Date: October 11, 2010  
To: Scott T. Anderson, Division of Solid and Hazardous Waste,  
Director  
From: Michael Hawley, EIT  
Subject: Additional information West Side Class IV Landfill Permit  
Application

# Class IV Landfill Permit Application West Side Landfill

# SANPETE COUNTY BARTON EXCAVATION LANDFILL IMPROVEMENTS 2010

SANPETE COUNTY		SHEET NO. DT-01

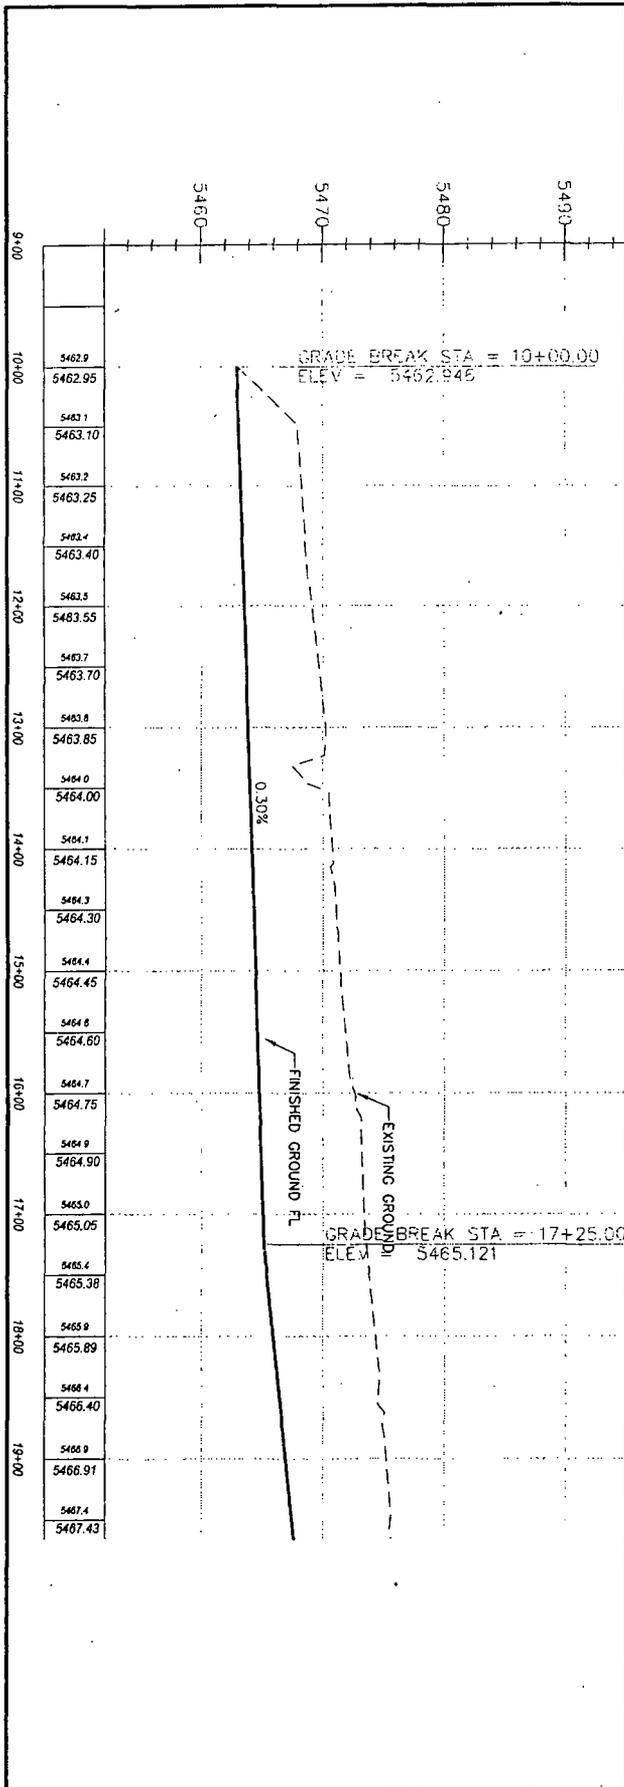
1. The landfill cap was revised to reflect a minimum of 24 inches of compacted fill over the debris instead of 18 inches. Slight changes were made to the flow line profile in the construction plans to generate the additional fill required to provide the 24 inch cap.
2. Notes were added to the construction drawings to require dust control and watering to control fugitive dust and ensure adequate compaction of the fill.
3. A fugitive dust control plan for this site is also included in the attachments to this memo.

1. PROVIDE WATER IN ADEQUATE QUANTITIES FOR PRE-WETTING, MIXING, OR COMPACTING MATERIALS. PROVIDE ADEQUATE WATER SUPPLY FOR DUST CONTROL AT ANY TIME. DO NOT WASTE OR OVER SATURATE CONSTRUCTION AREAS.
